**City of Richmond**

**Report to Committee**

RZ 03-231923

**Re: APPLICATION BY GURDEV S. LEHL FOR REZONING AT 7831 BENNETT ROAD FROM SINGLE FAMILY HOUSING DISTRICT, SUBDIVISION AREA E (R1/E) TO COMPREHENSIVE DEVELOPMENT DISTRICT (CD/120)**

SITE PLAN  
 SCALE 1/8"=10'

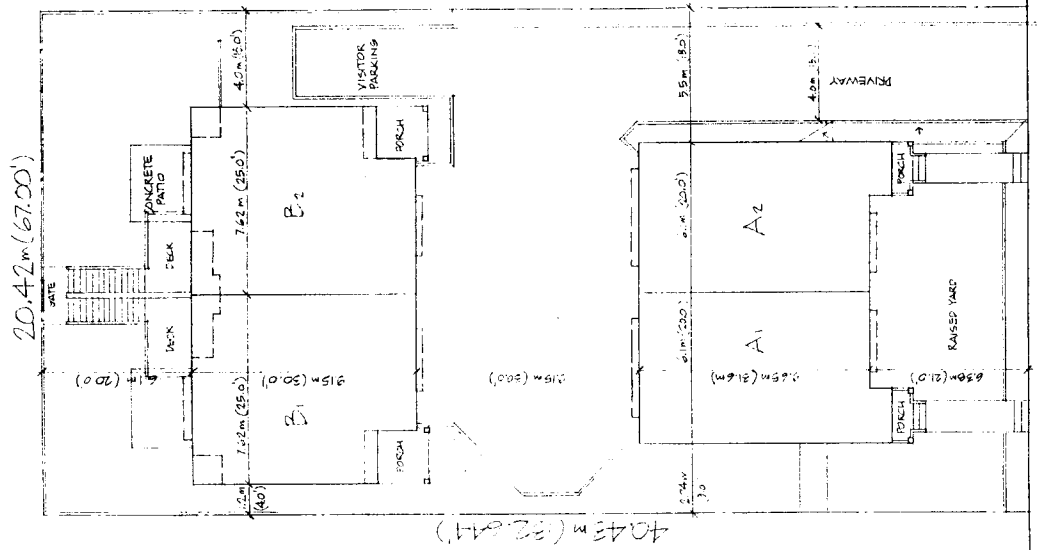
- A landscape architect should be retained to identify the location of the trees and shrubs on the subject property, Brighthouse Park and the Caring Place parking lot that are to be retained, relocated or removed. He/she must also ensure that the proposed new townhouses, decks and stairs are not located within the drip line of any significant trees on the City-owned lands.

- It is recommended that the driveway off Bennett Road also provide access to 7851 Bennett Road should it redevelop. This driveway should have a 4 m (13.1 ft.) driving surface adjacent to the eastern property line and fence so that if the adjacent property redevelops the driveway could be easily widened, with the fence removed, and a walkway would be provided to Brighthouse Park.

- The fence along Brighthouse Park, at the north property line, should be removed and replaced with a lower fence in order to enhance the park openness.

- The porches and front doors of the "B" units at the back of the site must be visible from Bennett Road. A pedestrian path should be provided to the "B1" unit along the western property line to Bennett Road.

- Relocate or delete the visitor parking space and replace with a landscaped pathway to provide access to Brighthouse Park from the site. Relaxation of the required visitor parking space is supported. A gate should be provided in the new fence, for access to the park.
